Access Compliance Report

Public Rights-of-Way

(Curb Ramps)

Intersection ID: 52303	Main Street: VIBURNUM_CT	Cross Street: SNOWBELL_CT	Location: SE
ADA ID: 8E54022271F3	Ramp Type: Perpendicular	Initial Pass/Fail: Fail	Overall Compliance: No
Codes/Mitigation Info/Possible Solution		Field Measurements/Component Compliance	
Severity Score: 13.75

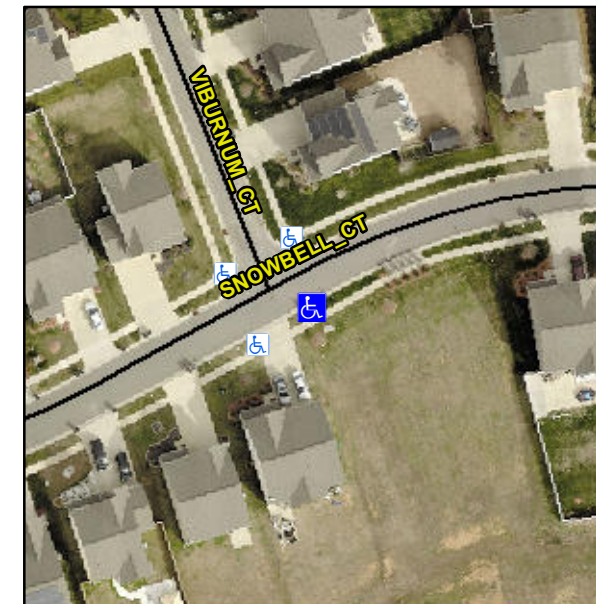
Not Found, R304.2.2, R304.5.3

Compliance	Description	Data	Compliance	Description	Data
N/A	Ramp Length (in)	71.5	No	Ramp Slope (%)	10.0
Yes	Ramp Width (in)	48.0	No	Ramp XSlope (%)	2.3
N/A	Flare Type LT	N/A	N/A	Flare Type RT	N/A
N/A	Flare Slope LT (%)	N/A	N/A	Flare Slope RT (%)	N/A
N/A	Flare Traversable LT?	N/A	N/A	Flare Traversable RT?	N/A
N/A	Landing Length (in)	N/A	N/A	DWS Provided?	N/A
N/A	Landing Width (in)	N/A	N/A	DWS Contrast?	N/A
N/A	Landing Slope (%)	N/A	N/A	DWS Length (in)	N/A
N/A	Landing X Slope (%)	N/A	N/A	DWS Full Width?	N/A
N/A	Landing Curb? (Y/N)	N/A	N/A	DWS Offset (in)	N/A
N/A	Shared Landing?	N/A			
N/A	Gutter Ponding?	N/A	N/A	Gutter Slope (%)	N/A
N/A	Gutter Lip Ht (in)	1.0	N/A	Gutter X Slope (%)	N/A
N/A	Painted X Walk1?	No	N/A	Painted X Walk2?	N/A
	X Walk 1 Direction	To N		X Walk 2 Direction	N/A
N/A	X Walk 1 Width (in)	N/A	N/A	X Walk 2 Width (in)	N/A
	X Walk 1 Slope (%)	2.7		X Walk 2 Slope (%)	N/A
	X Walk 1 X Slope (%)	1.3		X Walk 2 X Slope (%)	N/A

Remove & Replace Entire Ramp.
